TSB # 18-2021

SUBJECT: Improper “Baffle Plate” Positioning

FIX ON FAILURE (Failure Code 18.21)

Effective serial number range: model year 2021 - 7000, 8000 and 9000 series air-seeders equipped with ASC

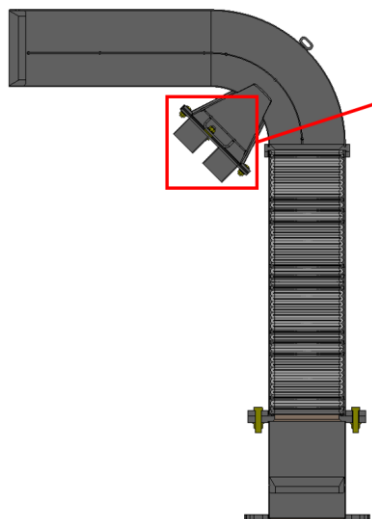
In model year 2020 a change was made to the ASC system where a “baffle plate” was installed in the clean air plenum – this baffle plate was introduced to improve the balance of the clean air flow when the section valves are closed, ultimately improving product cleanout over a wide range of rates and fan speeds.

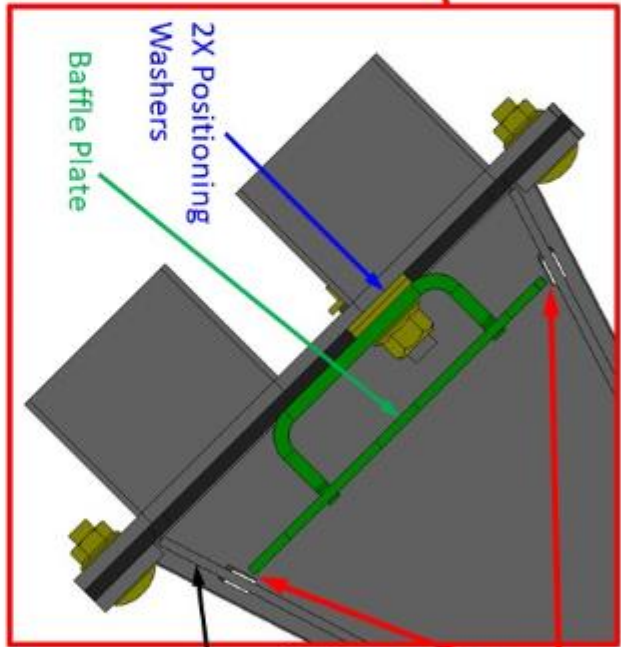
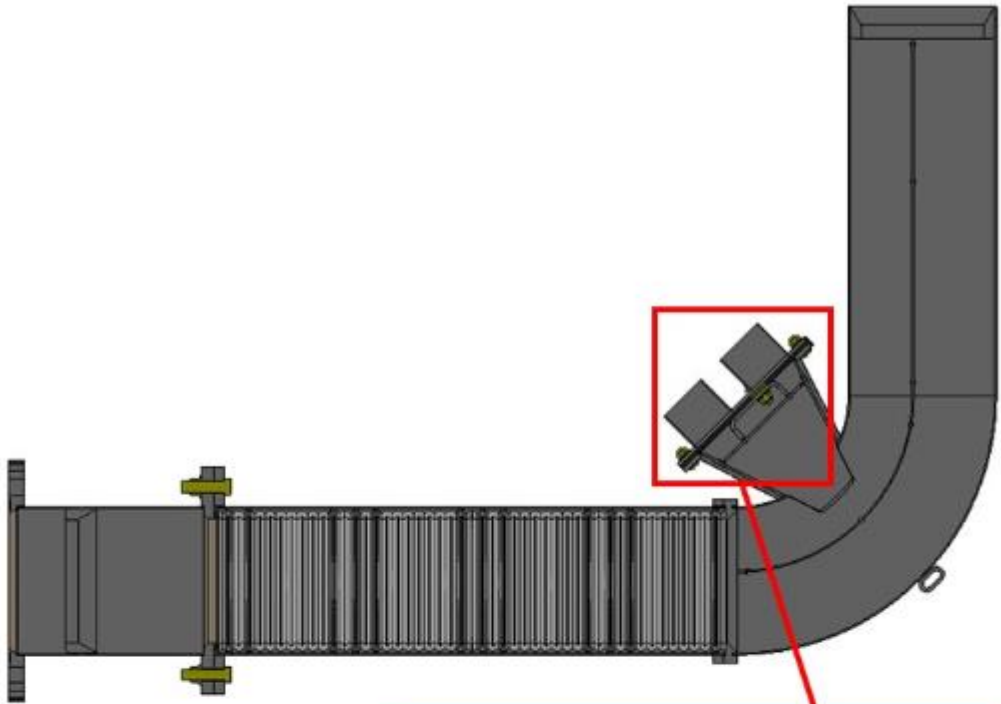
- The problems indicated above are the result of the baffle plate being tight against the plenum therefore restricting airflow
- To correct the problem perform the following steps

Gap Around Periphery of Baffle Plate to Plenum Body

Gap is Visible Through Clean Air Port

- The baffle plate is bolted to the plenum cover
 - Remove the plenum cover
 - The baffle plate most likely has two washers (acting as spacers) between it and the plenum cover

- Remove one washer – re-assemble and inspect for proper gap
 - Remove the second washer if proper gap is not achieved
 - Once proper gap is achieved test for proper function

- Ensure 3/32" to 5/32" Gap**
- Remove one washer, re-assemble to verify gap.
 - Remove second washer if required.
